# ***Interactive comment on “Comparing SWAT with SWAT-MODFLOW hydrological simulations when assessing the impacts of groundwater abstractions for irrigation and drinking water” by Wei Liu et al.***

**Wei Liu et al.**

Received and published: 17 October 2019

**Fig. 1.** Figure 1. Location of the Uggerby River catchment and Hjørring Municipality, and their delineation in SWAT and MODFLOW. The locations of wells distributed inside or outside the Uggerby River Catchment

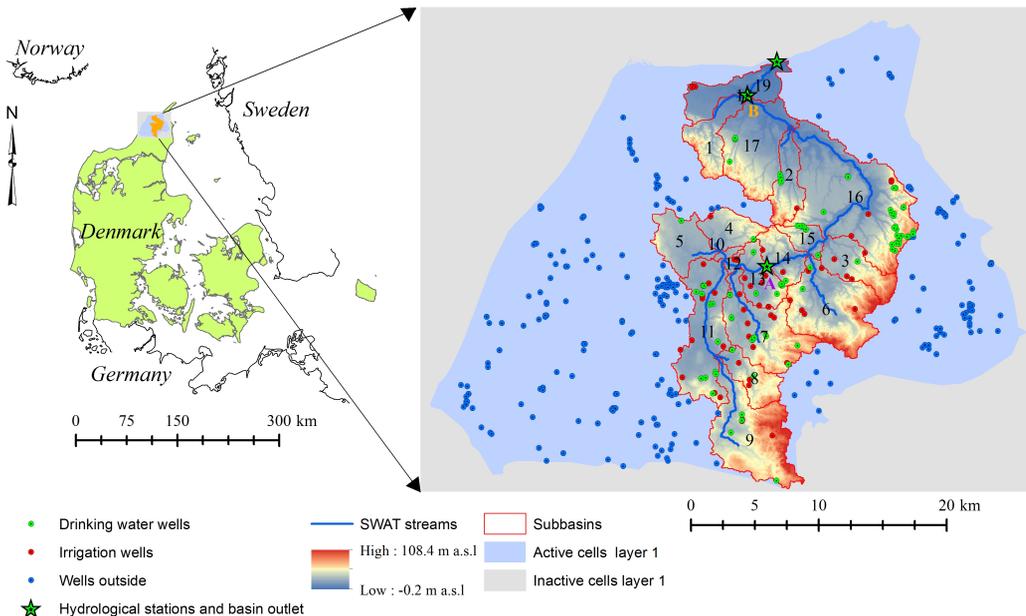
7) 2.1. Study Area. Is there water intrusion and lunar tidal influence at the watershed outlet? I recommend to include the groundwater watershed in this section.

**19)** Figure 3. I recommend replacing “coverage” by domain or extent.

**Response:** As far as we know the influence of water intrusion and lunar tidal on the outflow of the watershed is small. It is a good suggestion that the groundwater watershed should be included in the study area section.

Modifications: We have added the groundwater domain and wells to the map of the study area (Fig.1, as attached) and removed the figure 3. We also have removed the sentences related to Figure 3 in line 411-415. The caption of Fig.1 has been modified into “Location of the Uggerby River catchment and Hjørring Municipality, and their delineation in SWAT and MODFLOW. The locations of wells distributed inside or outside the Uggerby River Catchment are also shown.”

**Response:** We have combined Figure 1 and Figure 3 into one figure, as attached below, and have deleted the original caption of Figure 3.

**Fig. 2.** Appendix A. The hydraulic conductivities of each cell in each layer in the steady-state MODFLOW-NWT set-up.

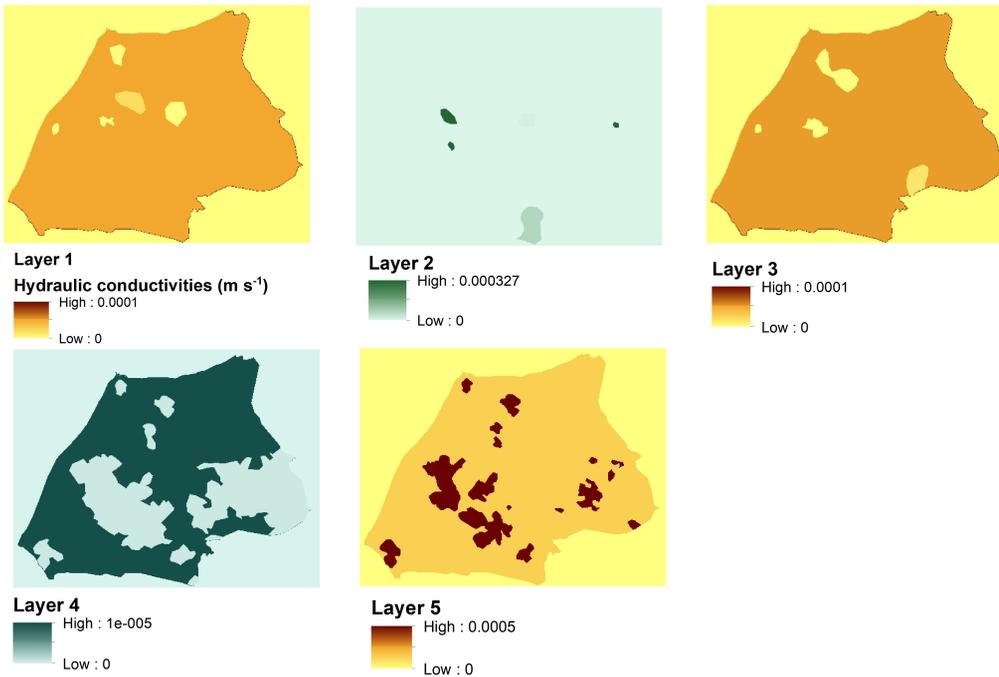
**11) 254:** Can the authors provide a figure that illustrates the hydrogeology of the study area?

**Modifications:** We have plotted a figure showing the hydraulic conductivities of each cell in each layer in the steady-state MODFLOW-NWT set-up and have added it to the Appendix as appendix A, as attached below. We also have added the following sentence into the manuscript:

Line 261-263. “The first, third and fifth layers are dominated by sand with relatively large hydraulic conductivities, while the second and fourth layers are dominated by clay with lower hydraulic conductivities (Appendix A).”
